TENNESSEE VALLEY AUTHORITY

August 8, 1980

A TVA-NRC meeting was held on July 29, 1980, to discuss the design of the TVA interim distributed ignition system for control of hydrogen in the Sequoyah Nuclear Plant containment. Enclosed are TVA's complete responses to 10 of the 11 action items requested of TVA during the July 29, 1980, meeting. Enclosure 1 is a list of the action items with a summary of the TVA response. Action item 7b, an analysis of heat fluence delivered to equipment and resultant equipment temperature environment will be submitted on or before August 12, 1980.

TVA ACTION ITEMS FROM JULY 29, 1980, MEETING
ON INTERIM DISTRIBUTED IGNITION SYSTEM

CONTAINMENT LIGHTING
FIGURE I.

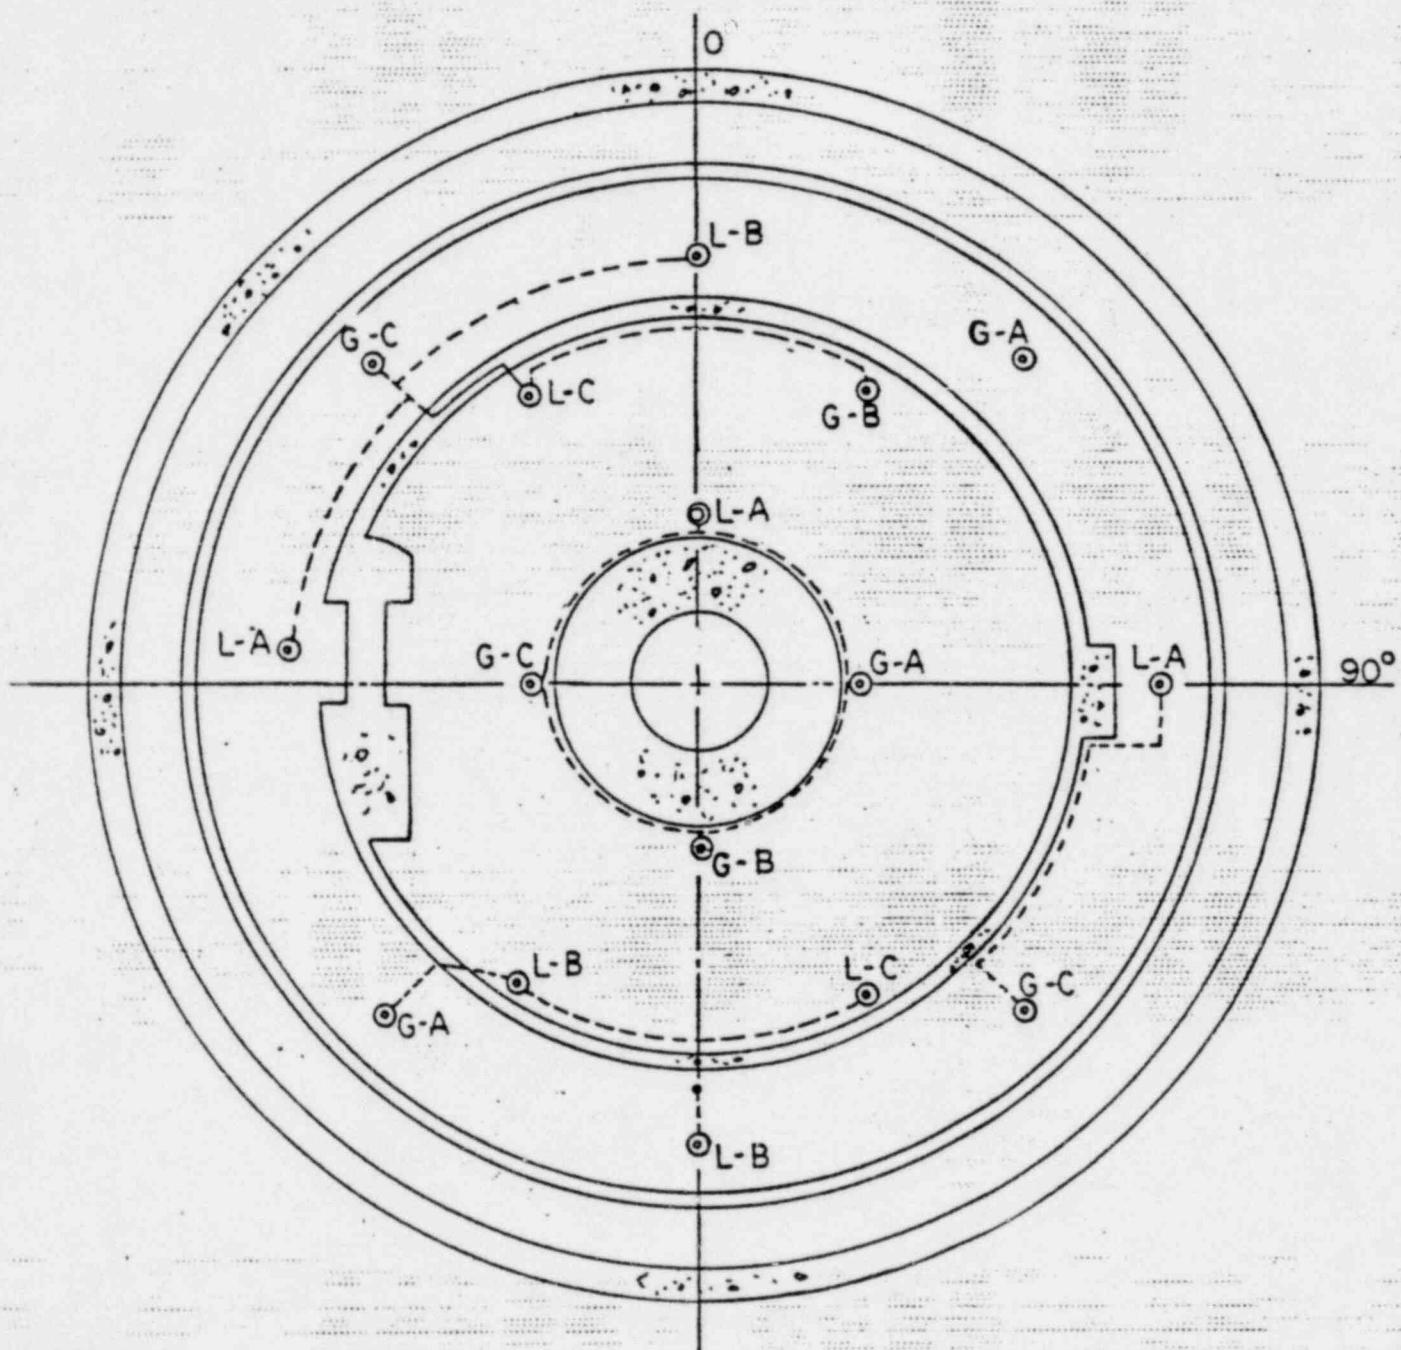
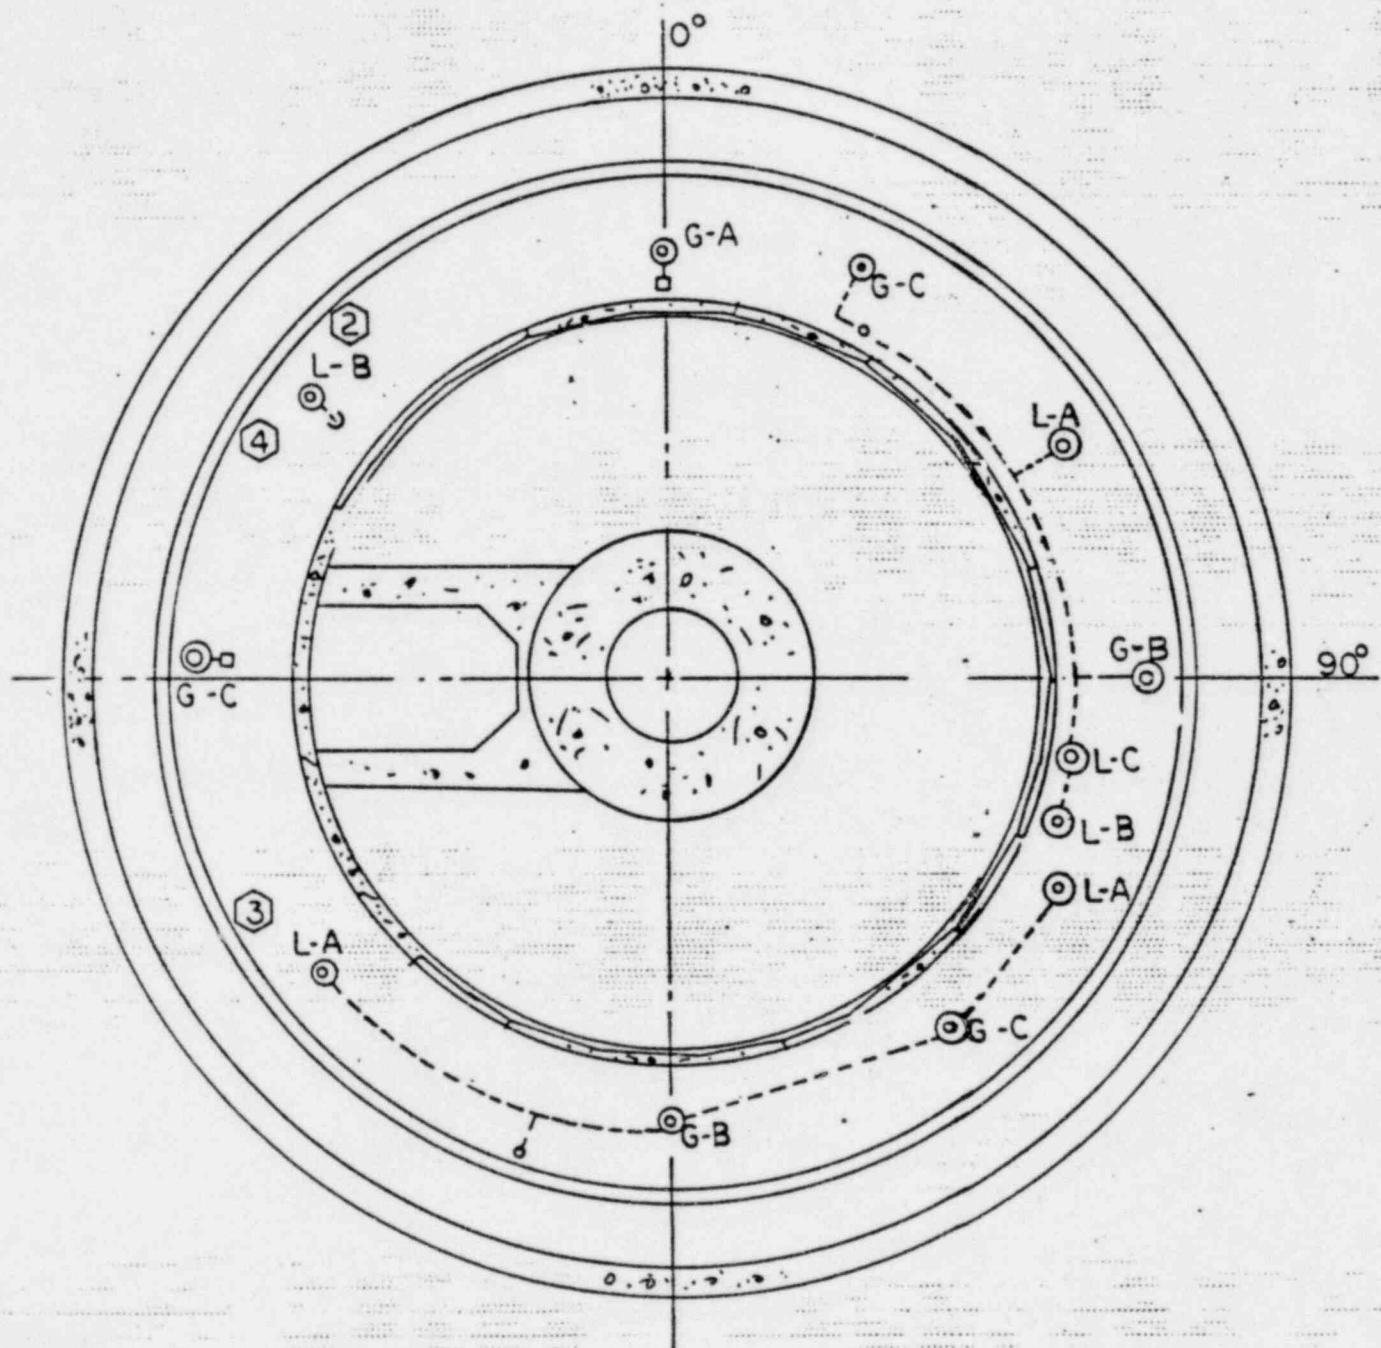
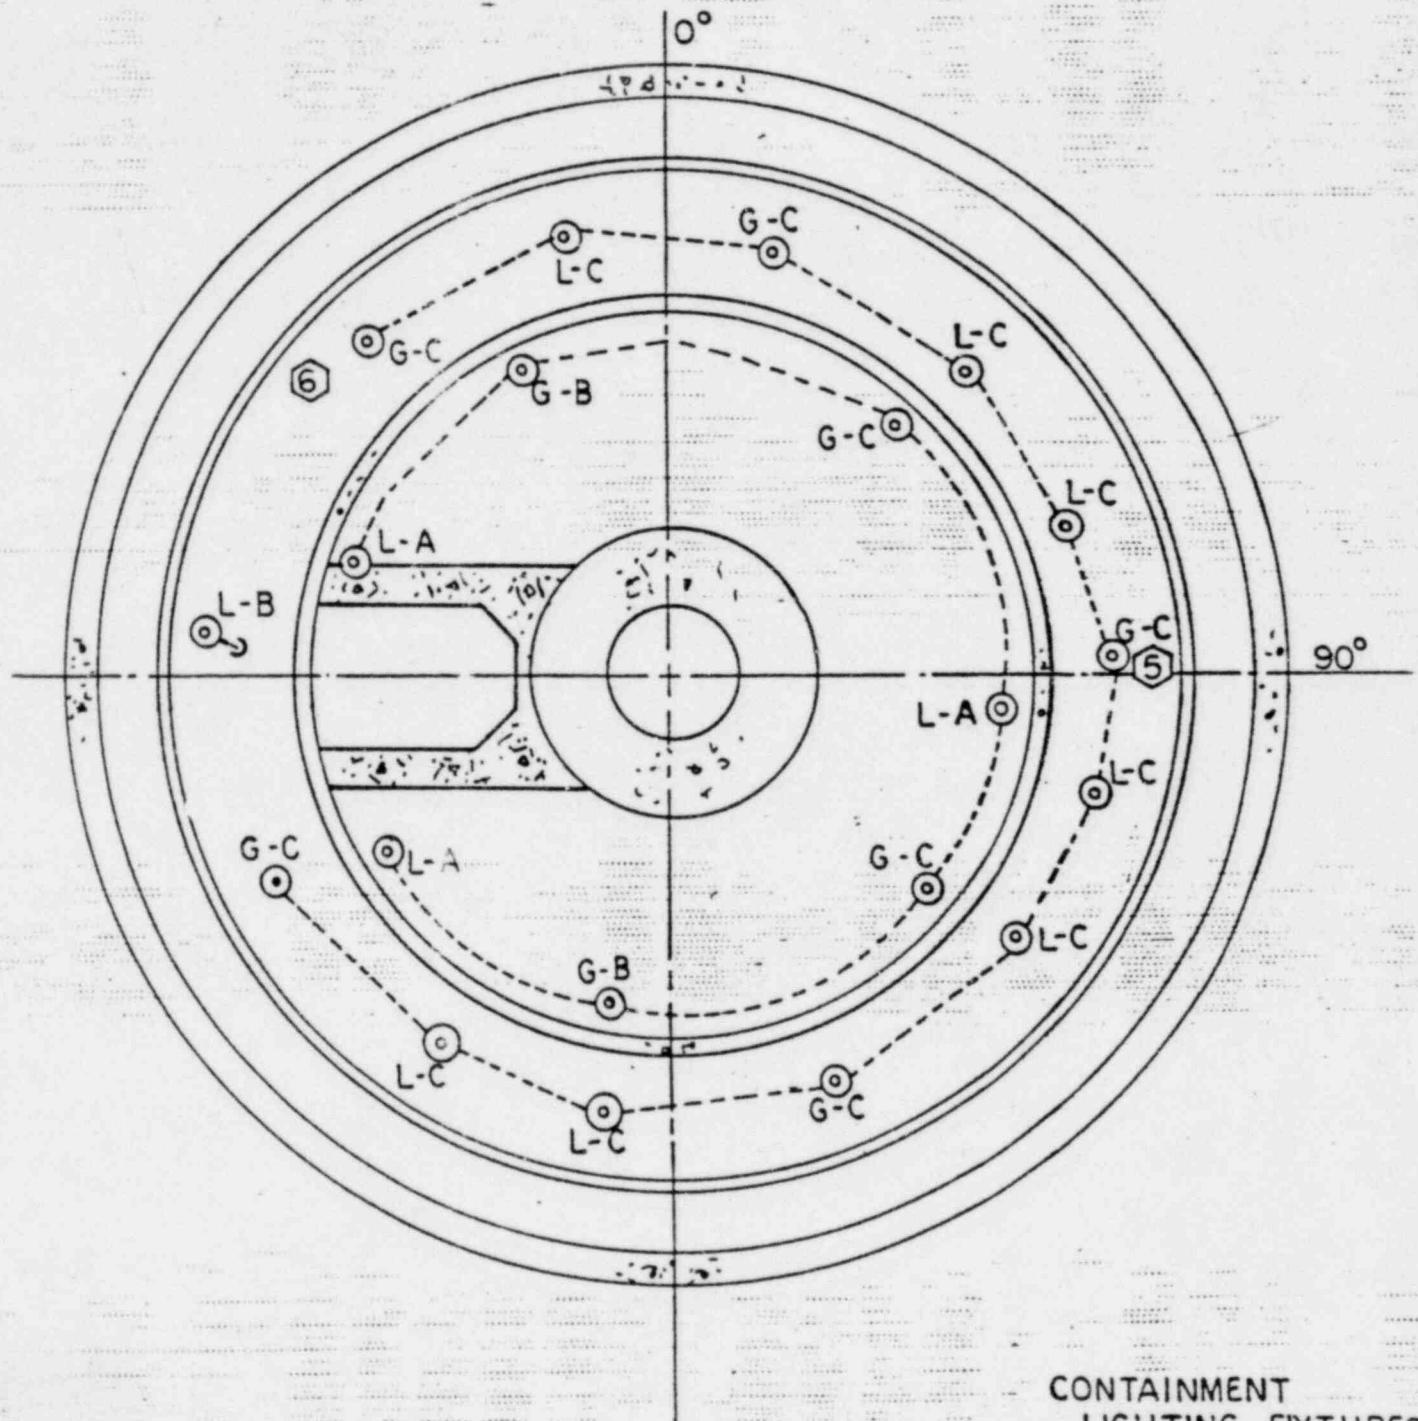
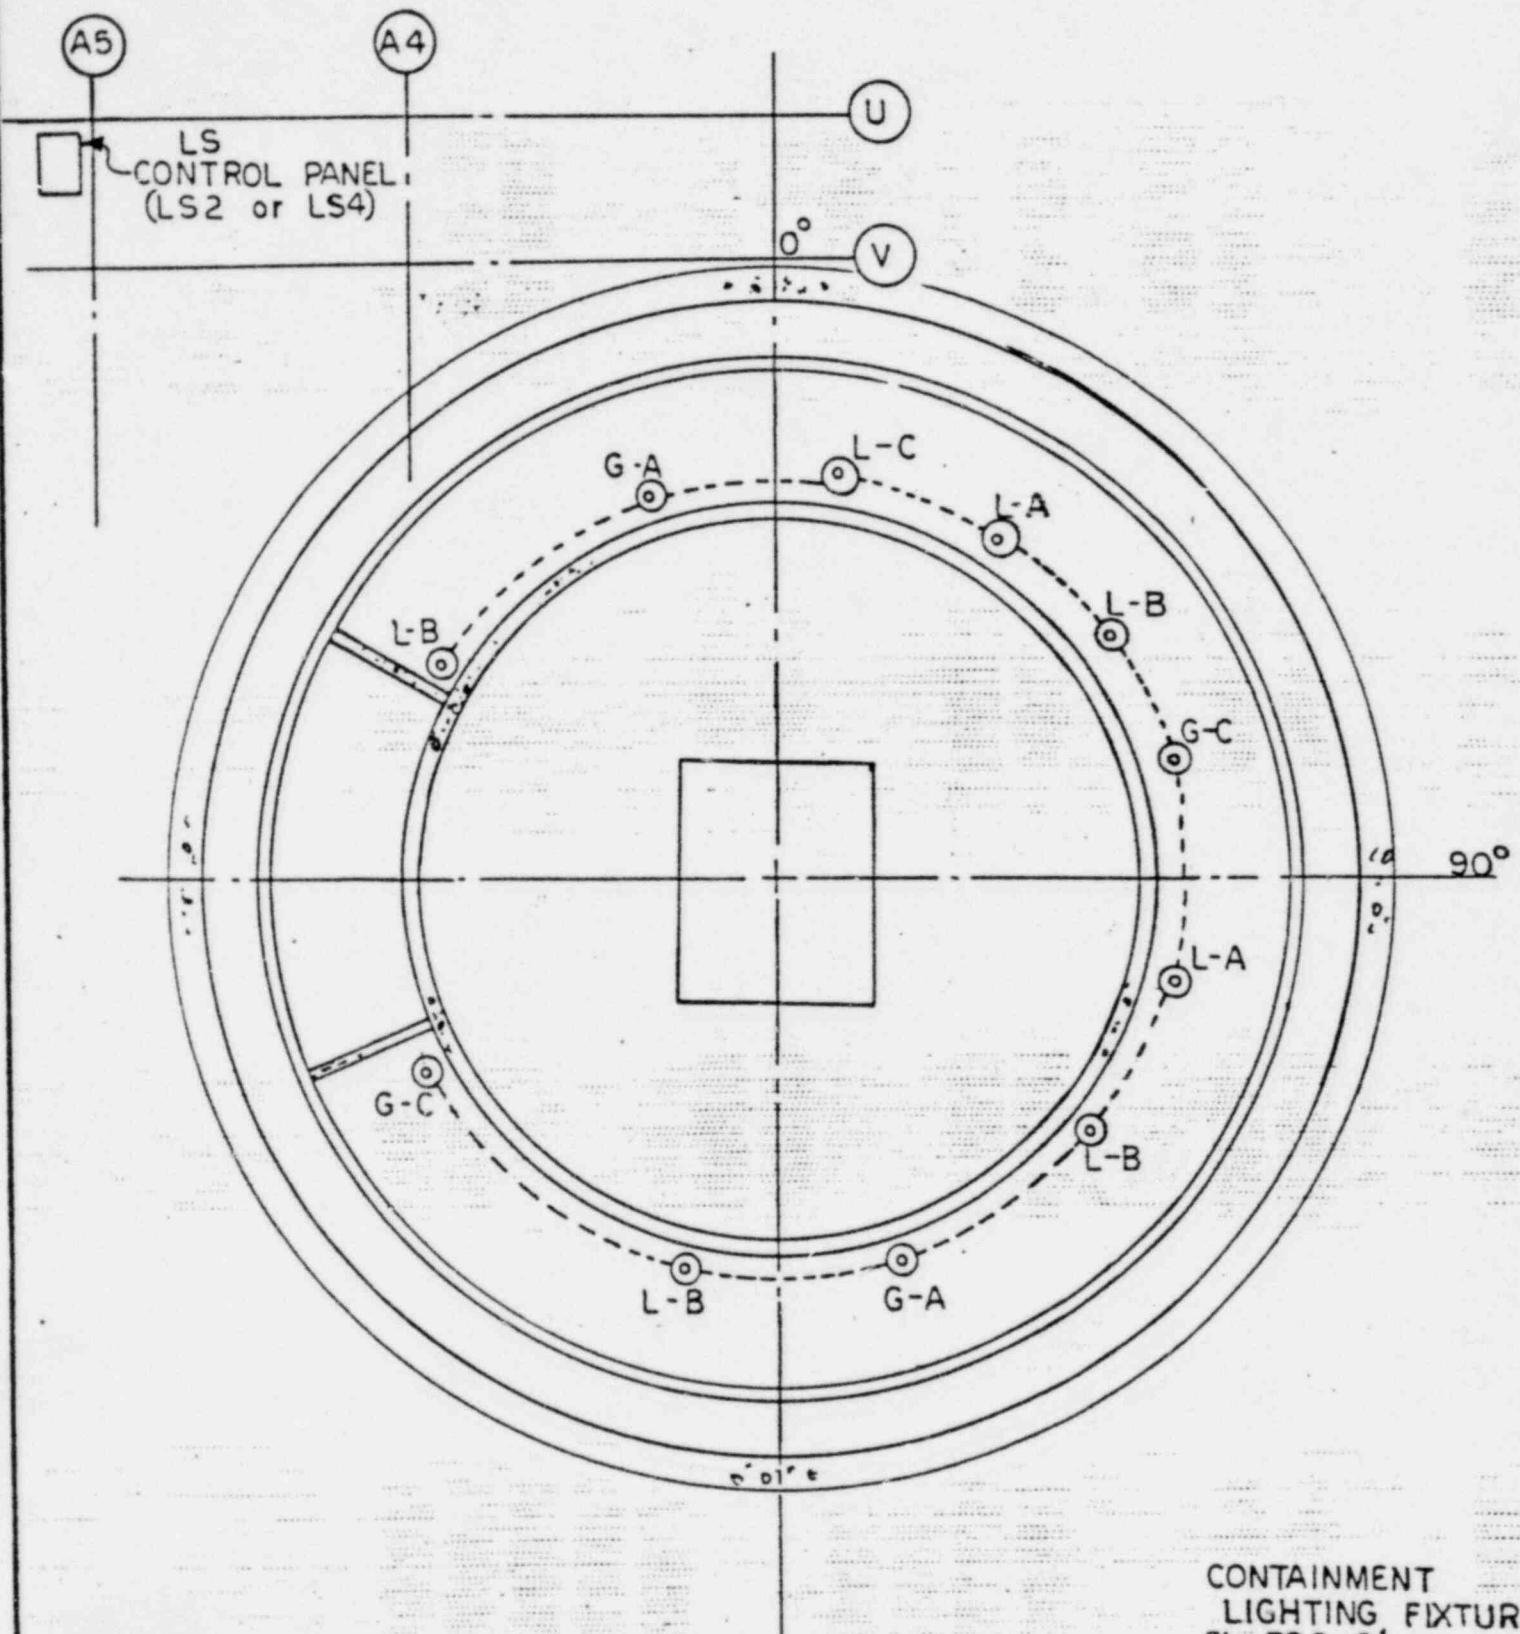
2. Location Drawings - Attached are the location drawings, figures 1 to 6, for each elevation.
3. Mounting Details - Attached is a drawing showing mounting details, figure 14.

- 5b. Location of Hydrogen Monitor Intakes - See figures 1-6.
6. Hydrogen Monitor Description - See Enclosure 2.
- 7a. List of Components Required after Hydrogen Burns - See Enclosure 3.
